# Rezoning Transportation Analysis

Petition Number: 2022-177

Date	Description
2-22-23	First Review (TM)

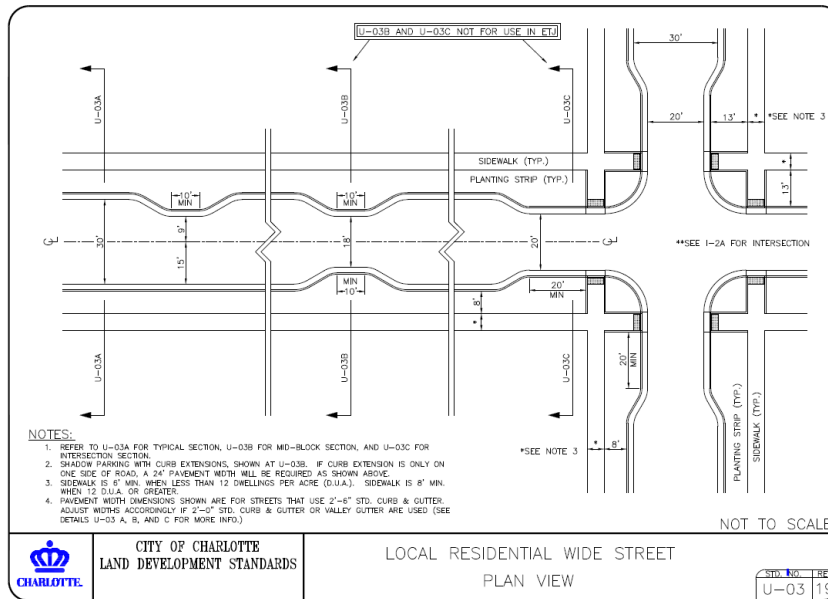
a. **Mallard Creek Road:** Location of curb and gutter to be moved to 33 feet from roadway centerline (continuing BOC location S of Galloway) to accommodate the NDOT STIP project U-6028 which widens Mallard Creek to 4+ lanes and Charlotte Streets Map with a roadway typical section of 4+ boulevard and shared use path.

b. **Galloway Road:** The future location of curb and gutter is in its existing location.

Label and dimension the curb and gutter from the centerline for each road on the site plan.
